CADIA HILL TAILINGS COMPLETION MODIFICATION
SUBMISSIONS REPORT

OCTOBER 2019
Project No. NEC-18-89
Document No. 01002285

CADIA VALLEY OPERATIONS
 Proposed Additional Groundwater
 Monitoring Bores for the
 Cadia Hill Open Pit

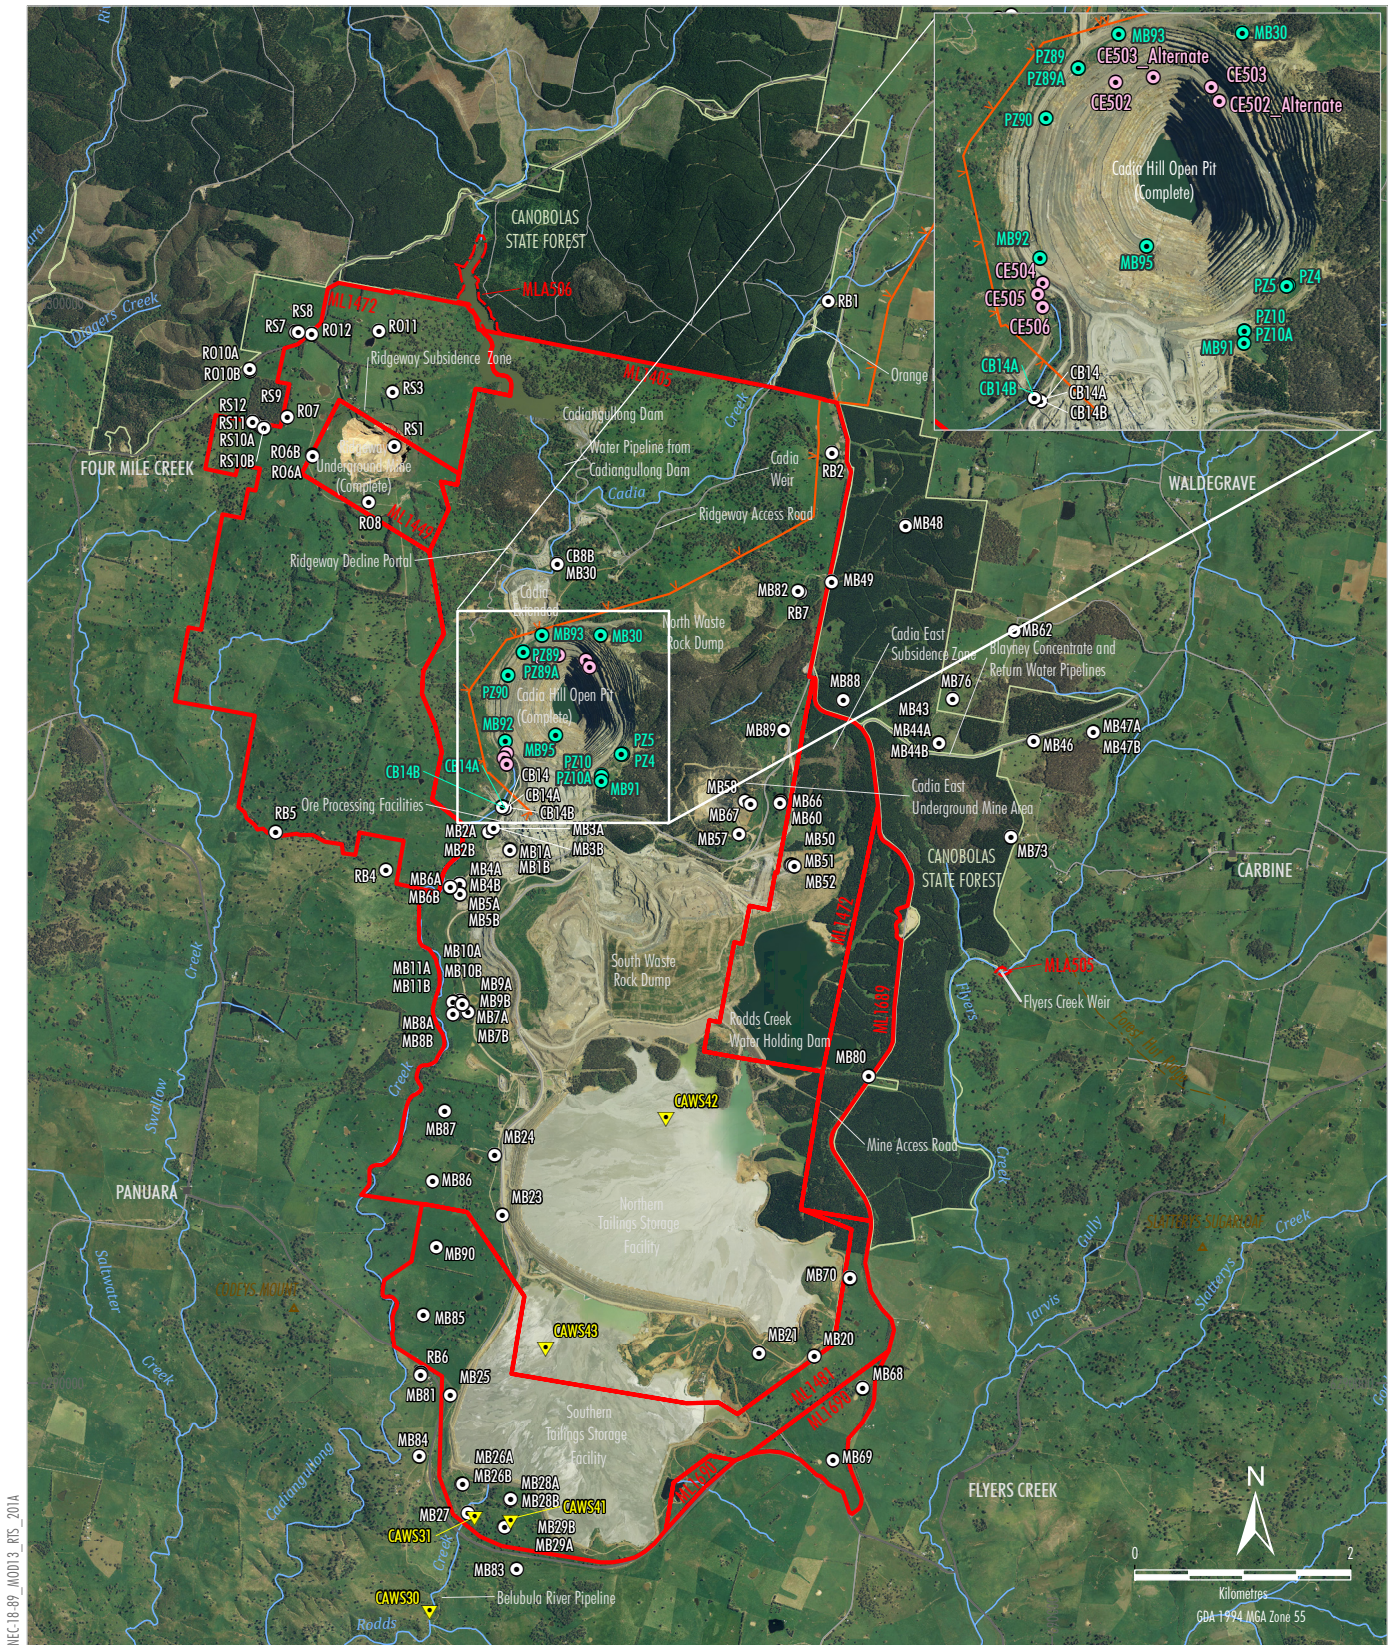
- The location/s of the proposed additional monitoring bores between Cadiangullong Creek and the south western boundary of the Cadia Hill Pit wall.

- An update of the CVO Water Management Plan, to include the proposed additional groundwater monitoring bores and management and contingency measures described in the Modification Report.
- The trigger standing water levels that indicate a reversal of the hydraulic gradient between the Cadia Hill pit wall and Cadiangullong Creek.

Since the Modification was submitted, surveys have been undertaken of the south-west corner of the Cadia Hill open pit to determine the most suitable locations for the proposed additional groundwater monitoring bores. The indicative locations of these bores are shown on Figure 3. These locations would be confirmed as part of an update to the CVO Water Management Plan (see below).

CHPL would prepare a revision to the CVO Water Management Plan within three months of approval of the Modification. This would include the additional groundwater monitoring bores shown in Figure 3, in addition to further detail regarding the management and contingency measures described in the Modification Report:

In addition, CHPL would establish a process to determine appropriate trigger standing water levels. These would be incorporated into the revised CVO Water Management Plan.
